ADDRESS: 1717-19 MOUNT VERNON ST

Proposal: Demolish rear ell, party wall and garage, construct side and rear addition with parking

Review Requested: In-Concept

OVERVIEW: This in-concept application proposes to make significant alterations and additions to the property at 1717-19 Mount Vernon Street in the Spring Garden Historic District. The western half, or 1719 portion, of the double-width property features a three-story brick main block and rear ell constructed c. 1859 and refaced in 1890, and a one-story frame rear addition. The eastern half, or 1717 portion, has historically remained undeveloped except for garage constructed between 1910 and 1916 at the rear of the lot and an iron fence at the front of the lot. Originally given separate registry plan numbers (5-N-21-188 and -189), but historically sold together, the properties appear as a single parcel in 1858-60, 1910, 1916, 1942 and 1962 historic maps, and as separate properties in the 1875 and 1895 atlases. They were eventually legally consolidated and given a single registry number.

1 FRONT ELEVATION
A200 1/4" = 1'-0"

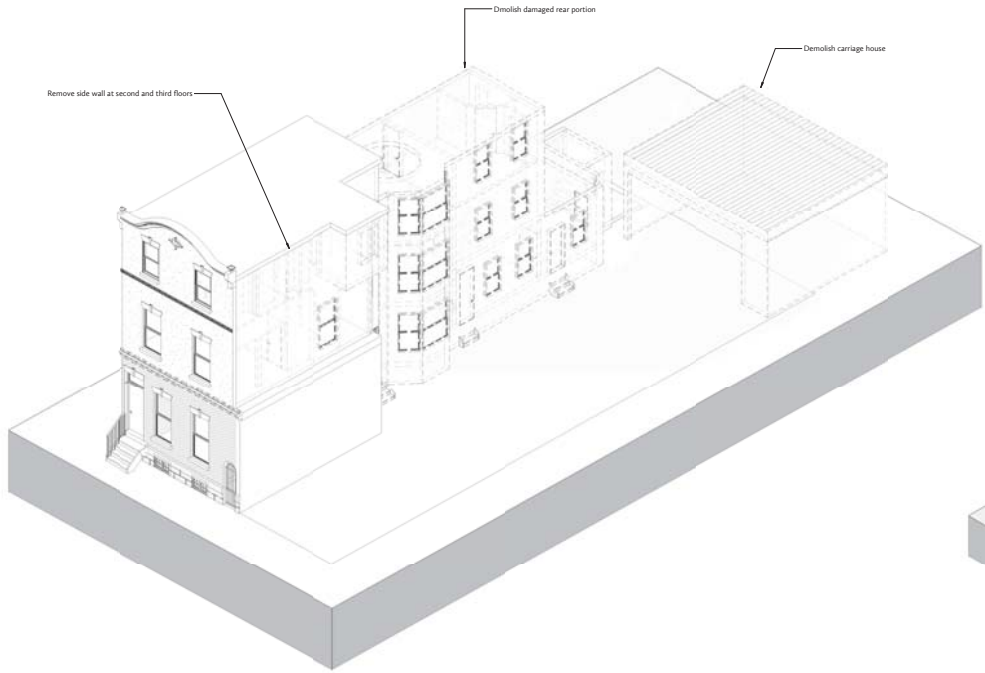
- The height, materials, and punched window openings on the second and third floors of the addition proposed along Mount Vernon Street are consistent with the scale, massing, materials and features of the Spring Garden Historic District; however the garage entrance Mount Vernon Street is not appropriate for this mid-block location, nor is the scale or massing of the new construction proposed at the rear. The application partially satisfies this standard.

1 Demolition Axonometric View

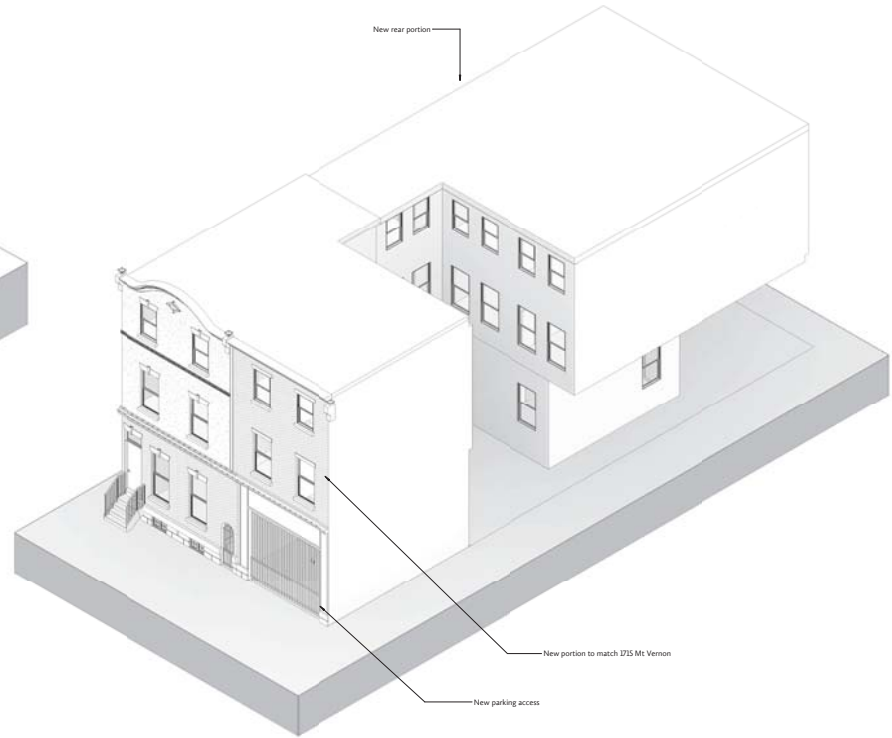
This application proposes to demolish the garage, rear ell, and second and third floor side walls of the main block and to construct three-story additions occupying the majority of the larger parcel. An engineer's report provided in the application claims that the rear ell is structurally compromised and must be demolished. Along Mount Vernon Street, the side addition would match the height of the existing building and feature a gated first-floor entrance to a below-ground parking garage. A new ell and rear addition occupying the full width of the property would be added at the rear.

- *Standard 2: The historic character of a property shall be retained and preserved. The removal of historic materials or alteration of features and spaces that characterize a property shall be avoided.*
 - Since it appears the property was originally intended to be two separately developable lots, the relationship of the historic building to the side yard side is not as significant as some double-width properties with highly ornate side bays and other detailing overlooking historic gardens, for example, so the Historical Commission staff does not oppose the concept of new construction on the 1717 portion of the property. However, the amount of demolition removes a significant amount of historic material of the historic property, including two-thirds of the side wall of the main block, the entire rear ell, and the garage. The application partially satisfies this standard.

- The application claims that the side wall of the rear ell is beyond repair, but does not propose to replace it in kind. The application does not provide information on the condition of the existing garage also proposed for removal. The application fails to satisfy this standard.

Sr. No	Image / Description	Location/Remarks
1.		<ul style="list-style-type: none">• Basement Northeast corner

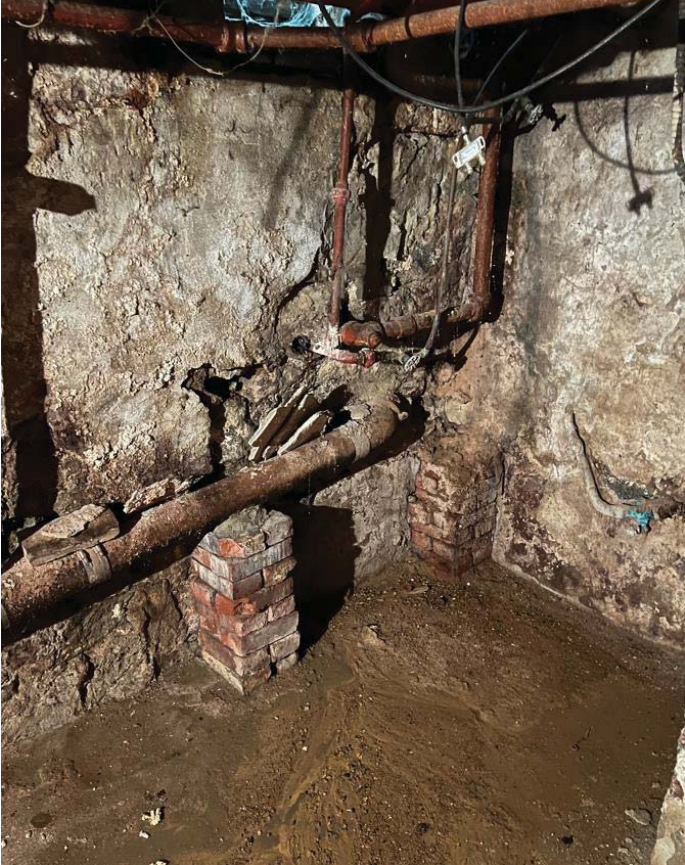
Issue 01: Foundation Settlement:

There are signs of water infiltration around the foundation walls. This water infiltration is caused by poor drainage and the soil conditions around and under the foundation. Water infiltration introduced into previously consolidated soil can induce secondary consolidation of the soil that will result in settlement of the foundation.

Repair/Replace Main Line. Check the main sewer line for damage that is allowing water to seep out of the line and into the soil around the foundation. Any cracks allowing water to infiltrate into the soil around the foundation must be repaired or replaced.

French Drain. A french drain is a perforated pipe just below the ground's surface. Water will soak into the soil and percolate up and into the french drain. As the water enters the drain it is then transported away from the home. Installing a french drain along the exterior perimeter of the home will help keep water from saturating the soils around the foundation and help to alleviate any additional pressures caused by water infiltration.

Sr. No	Image / Description	Location/Remarks
2.		<ul style="list-style-type: none">• Basement

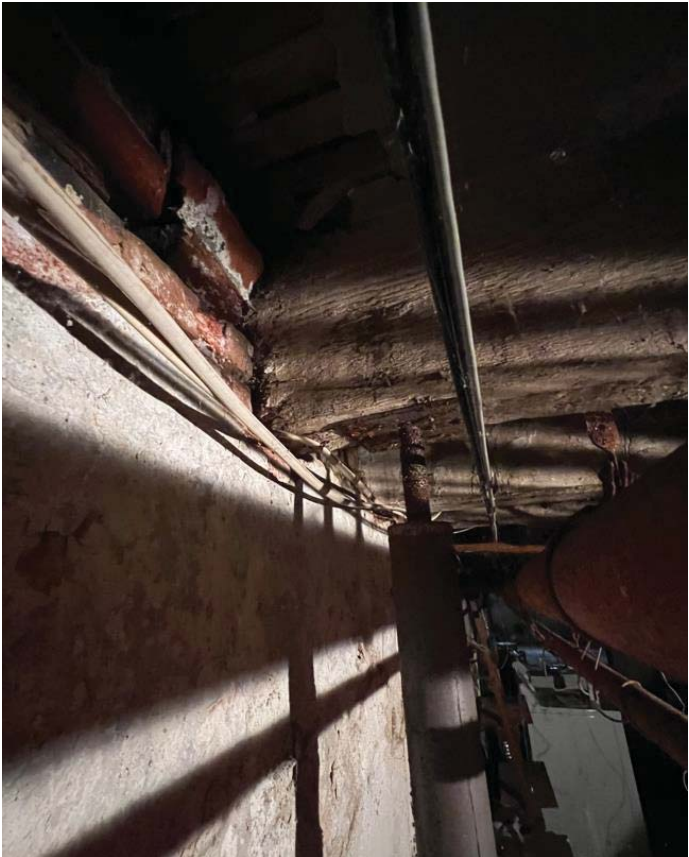
Issue 02: Joists Bearing Failure

The joists on the sidewall side of the basement are compressing where they rest on the exterior wall. This type of failure is called a bearing failure and is the result of water infiltration on the exterior wall that is damaging the joists and causing it to compress. As a result of this compression the floors above the joists are starting to deflect and sag.

Beam/Column/Footer. Install a 2-2"x12" Beam that spans a maximum of 10' The beam should be supported on either side by a 4"x4" wood post on top of a 18"x18"x12" concrete footer with 4-#4 reinforcement bars going each way

Sr. No	Image / Description	Location/Remarks
5.	 	<p data-bbox="1214 281 1438 390">Level 02 Image a, b and c locations</p> <p data-bbox="1214 1058 1438 1436">Horizontal cracks emanating at the ceiling level damaging top cornice along the entire length of the front façade at level 02</p>

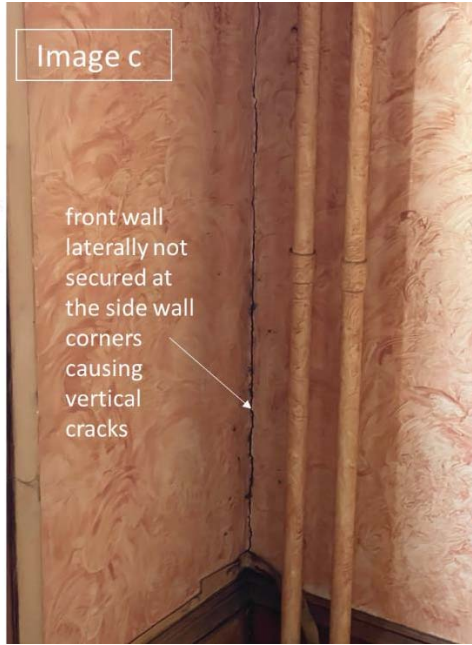
Issue 04: Facade Bowing

Front wall in not laterally secured by the floor joists (very common in this type of constructions). Additionally, the foundation on the front corner of the house is settling and causing the brick facade in the corner above it to separate. This settlement is the result of secondary settlement caused by water infiltration. The voids/cracks begin to open in the layers of brick and is visible from inside. If this remains un-attended the water will infiltrate those voids and will freeze and expand in the winter slowly separating the layers of brick.

Vertical cracks visible along the entire height of level 02 at the front wall location.

Install 3-star bolts on the front façade at both the levels. These star bolts should be spaced evenly along the front facade both vertically and horizontally

Sr. No	Image / Description	Location/Remarks
6.		Side wall Image a, b, c, d, e and f locations

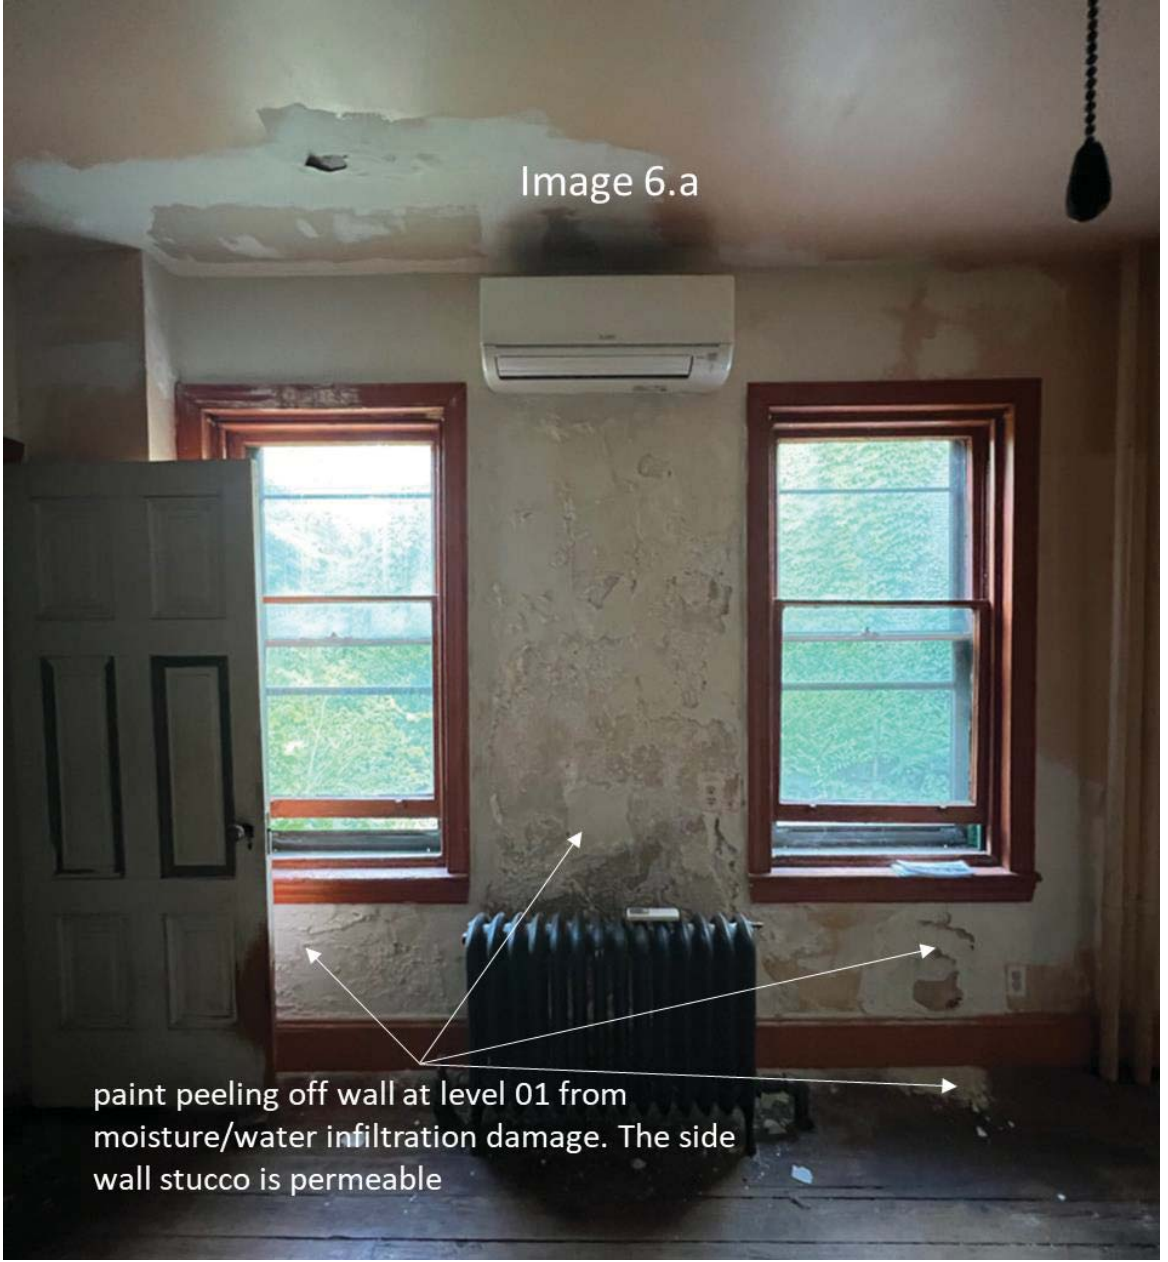
Issue 05: Damaged Side Wall**

The side wall has lost its water-resistant characteristic and has become water/moisture permeable. The prolonged water/moisture infiltration has compromised the structural integrity of the entire side wall at all the levels. The following photos of the wall from inside documents the damages caused from water infiltration at different levels and locations. Since the side wall is load bearing and supports all the floor joists, these damages present a dangerous situation. In case if the side wall fails the floors that it supports will also fail.

The structural integrity of existing side wall is compromised and is beyond salvageable (needs to be demolished/cannot be repaired).

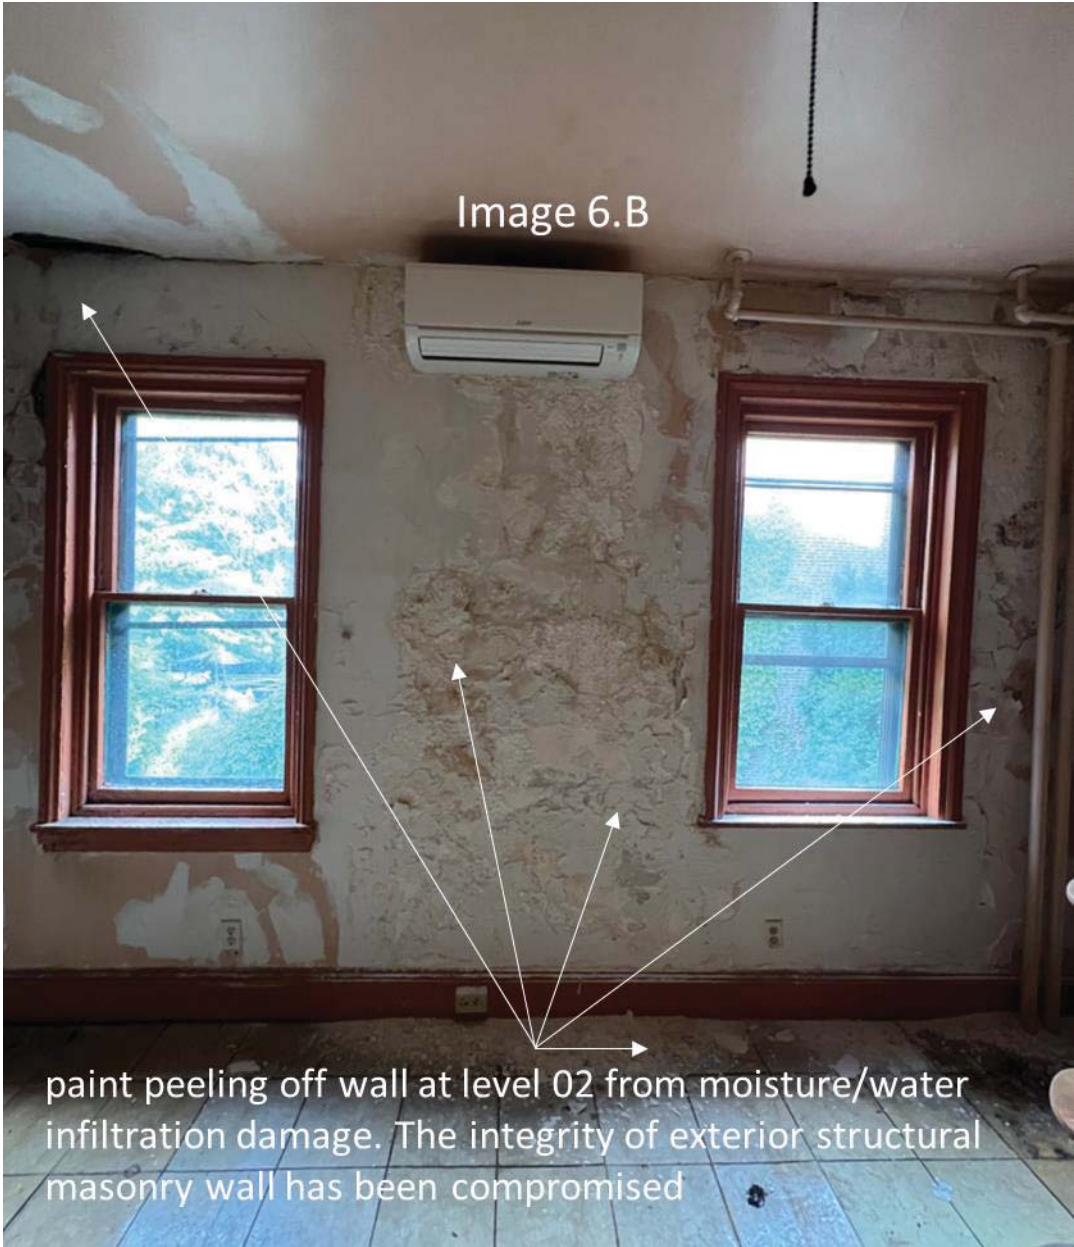
Sr.No.	Image 6.B
6 continued	 <p data-bbox="787 510 982 556">Image 6.B</p> <p data-bbox="378 1377 1312 1520">paint peeling off wall at level 02 from moisture/water infiltration damage. The integrity of exterior structural masonry wall has been compromised</p>
Remarks	Water/Moisture infiltration damage at level 02 is causing paint to peel along the entire length and width of the wall. Prolonged exposure to moisture undermines the structural integrity of masonry/wood framed wall

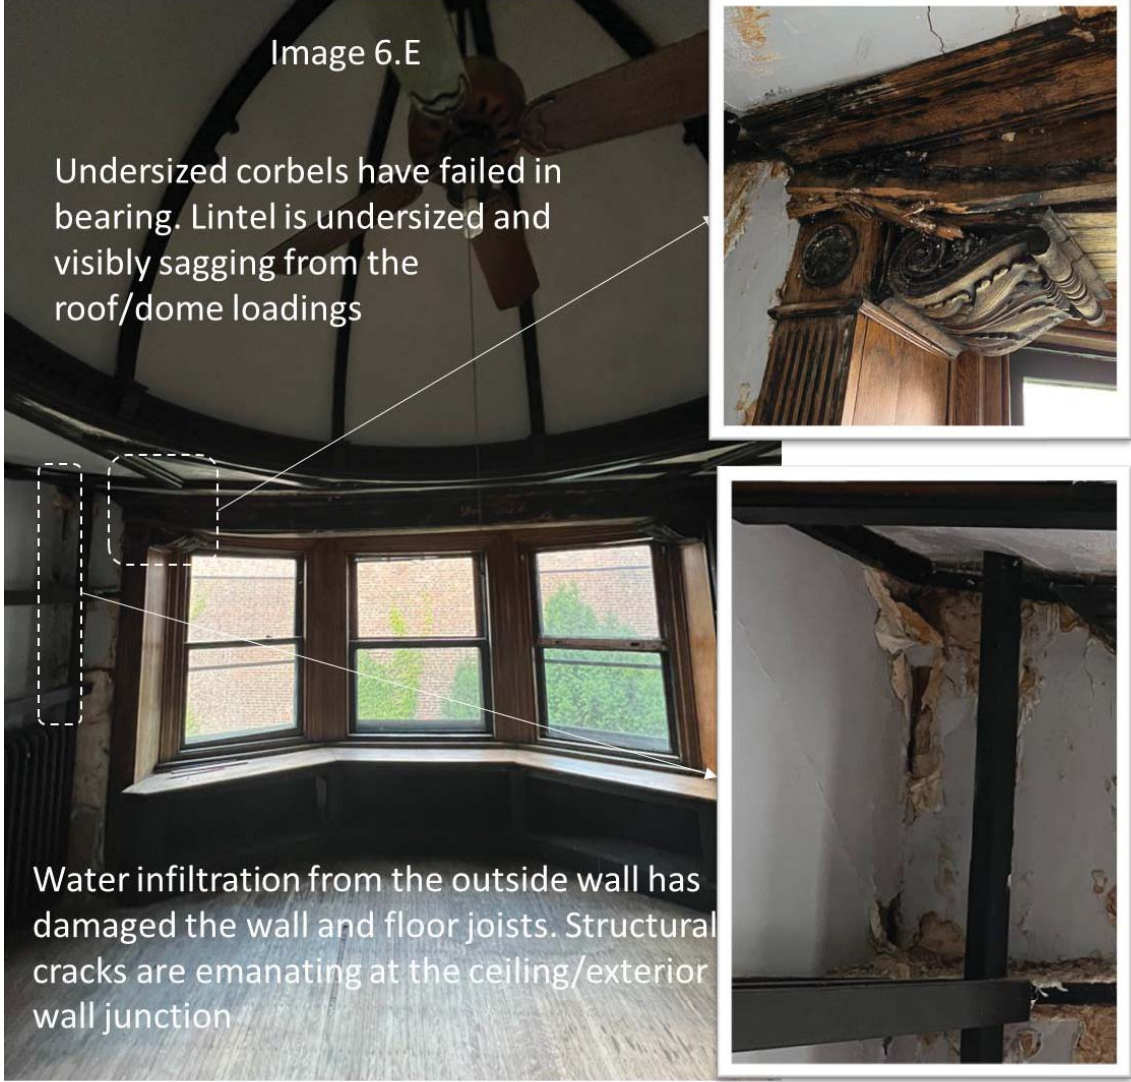
Sr.No.	Image 6.E
6 continued	<p data-bbox="613 327 764 365">Image 6.E</p> <p data-bbox="396 447 906 621">Undersized corbels have failed in bearing. Lintel is undersized and visibly sagging from the roof/dome loadings</p>  <p data-bbox="375 1150 1057 1325">Water infiltration from the outside wall has damaged the wall and floor joists. Structural cracks are emanating at the ceiling/exterior wall junction</p>
Remarks	Water/Moisture infiltration damage at level 03/roof is causing paint to peel along the entire height/sides of bay window. Undersized lintels/corbels have failed in bearing.
